## Index 700-110 Mounting Exit Number Panels To Signs

This Standard was modified around 2018 and a callout was not copied over as required. We added the missing callout and made some minor callout changes for clarity.

SIDE ELEVATION

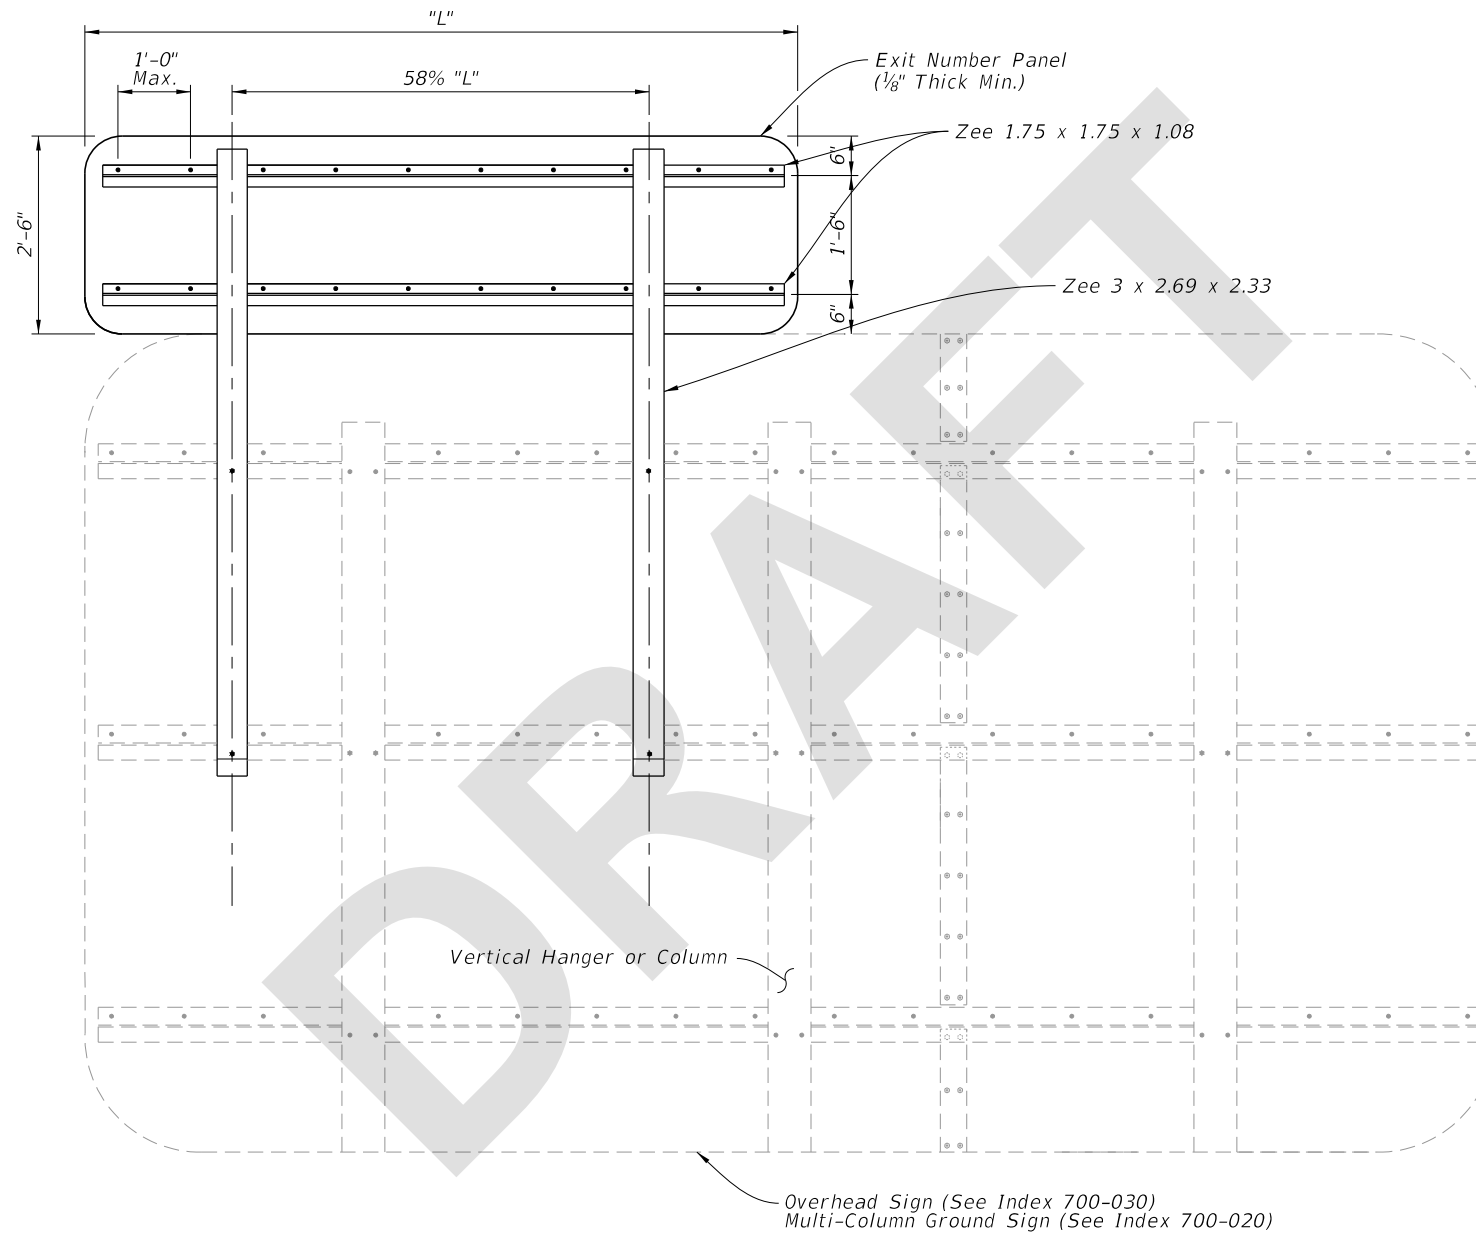
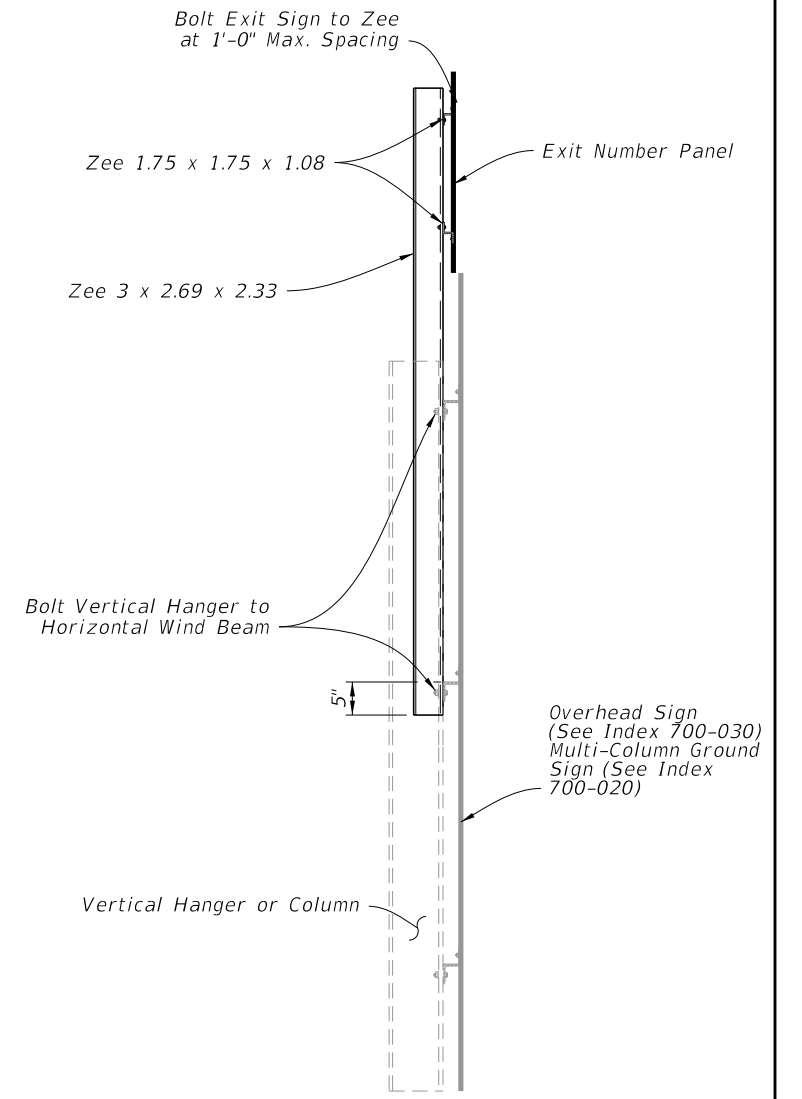
**COMMENT:** The note that was added for the "Side Elevation" should read "Multi-Column Ground Sign"....the word "Sign" is missing.

**RESPONSE:** Thanks for the comment. This has been fixed.

**CHANGE MADE TO INDEX:** Yes, updated the callout.
